Document: Draft, Phase 1 Evaporation Ponds Characterization Data Summary Report Update, Anaconda Copper Mine Site – Yerington, Nevada, August 18, 2017

Reviewer: Yerington Paiute Tribe

Figure 1. Elevation of pond bottom/sediments at two locations in the northern set of ponds compared to groundwater levels in nearby shallow wells. Well log presented in Figure 2.

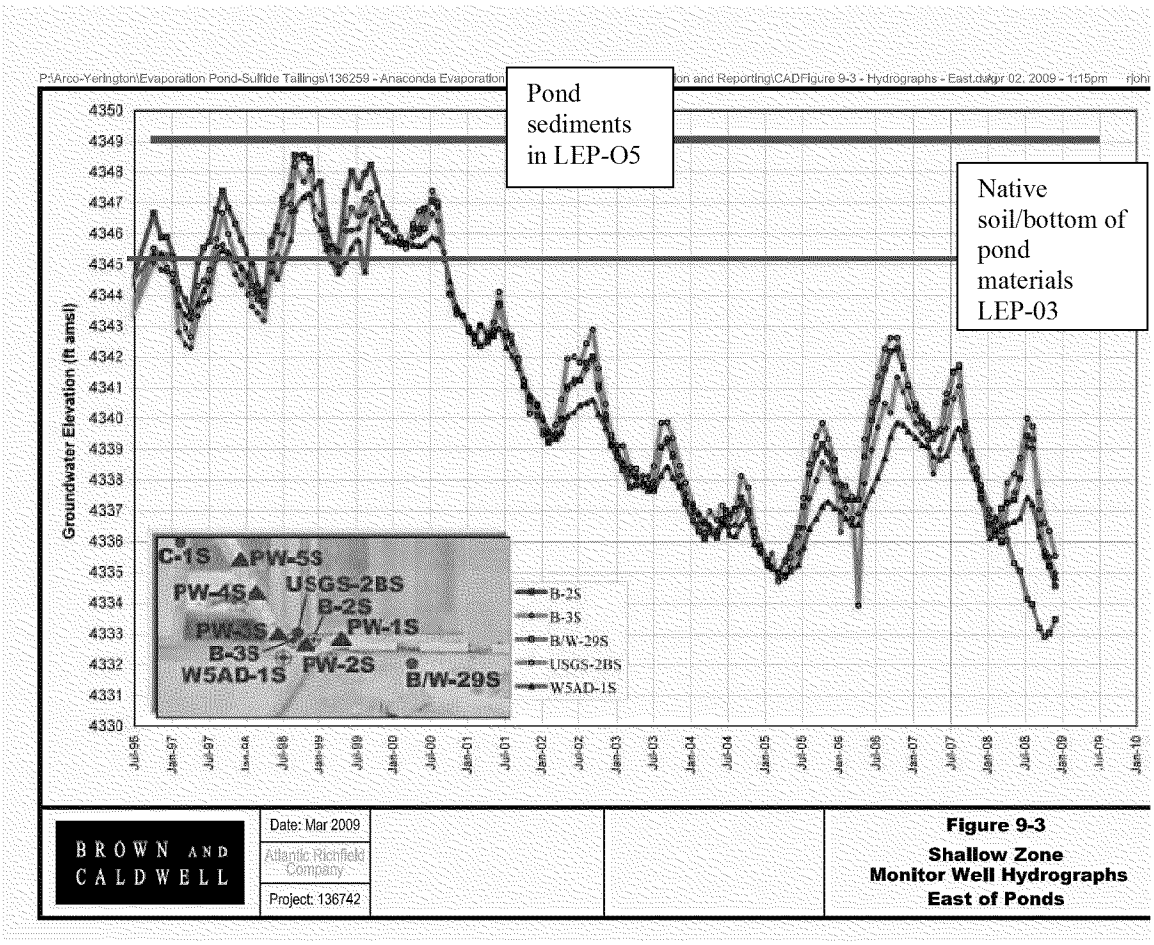
8. Section 3.4 makes the assumption that transport is only due to accumulation of precipitation in the ponds facilitating downward migration of COCs. Groundwater levels have historically been at elevations associated with sediments in the ponds with up to 5 feet of sediments potentially within the saturated zone (Figure 1 through Figure 3).

These data indicate that even with pumping of the shallow groundwater from multiple nearby downgradient locations, groundwater has recently been in contact with pond sediment. Historic data indicates that is not an isolated event (Figure 3). Adding to this, these groundwater measurements are from lower pit lake levels. As the pit lake water levels increase, groundwater will follow increasing the incidence of evaporation pond sediments saturated by rising groundwater.
